Technical Service Bulletin – 015

HELM Damper - Rebound

Rev01 – 5/2/17 - Mike M

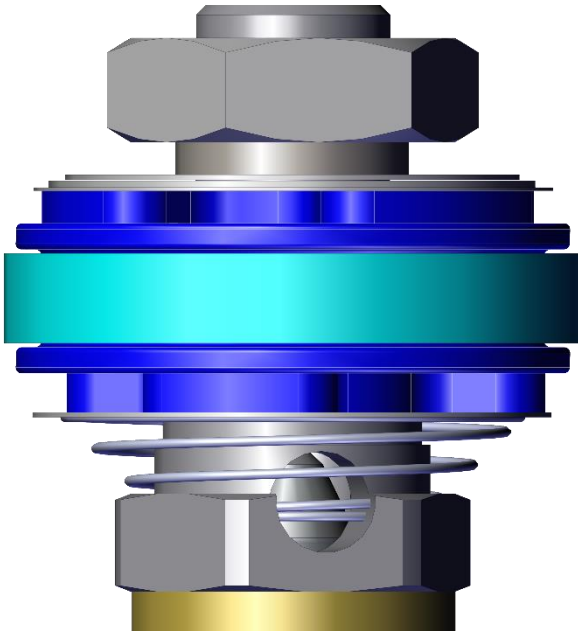
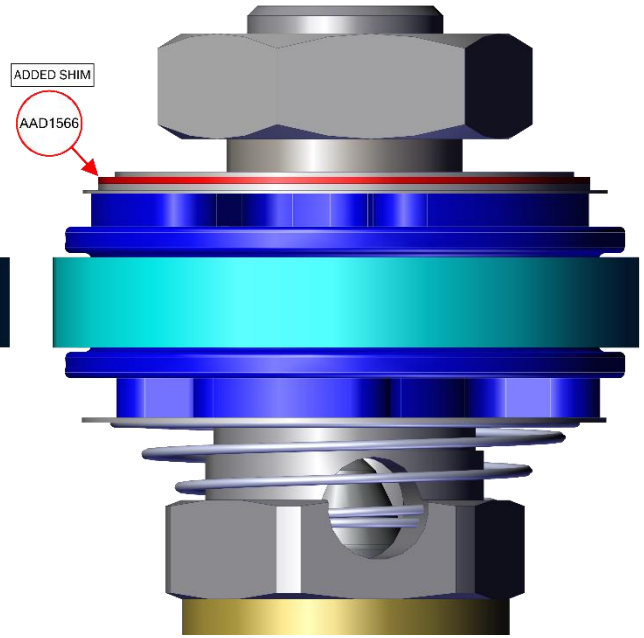
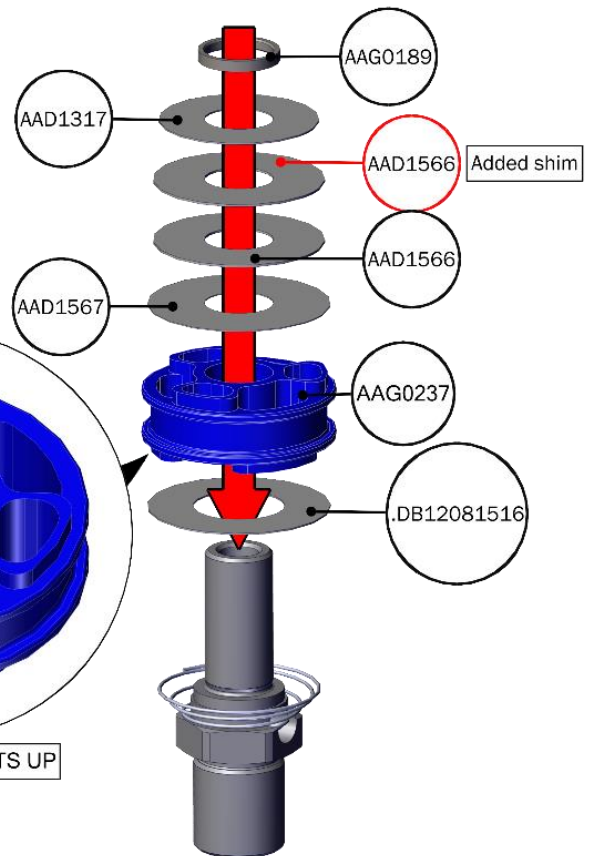
In Late April Cane Creek made a change to the rebound performance on the Helm fork. We did this by flipping the rebound piston and adding a shim to the shim stack. By doing this we can provide greater range of rebound damping force.

FLIPPED REBOUND PISTON

ADDED SHIM TO SHIM STACK

ADDED SHIM

SMALL PISTON PORTS UP

All Helm forks build on May 3 and after will receive this change.

This service to the rebound can be performed by a qualified service center if needed.
